Additions and Corrections

The following presents additional information and technical errors found between June 15, 2016, and October 11, 2019, in the SI editions of the 2016, 2017, 2018, and 2019 *ASHRAE Handbook* volumes. Occasional typographical errors and nonstandard symbol labels will be corrected in future volumes. The most current list of Handbook additions and corrections is on the ASHRAE web site (www.ashrae.org).

Fig. 13 Typical Performance Data for Rotary Solid Desiccant Dehumidifier

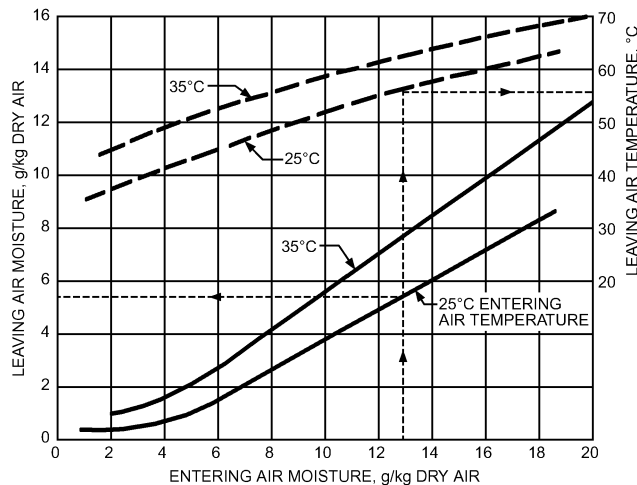
p. 24.7, Fig. 13. The correct SI graphic is below.
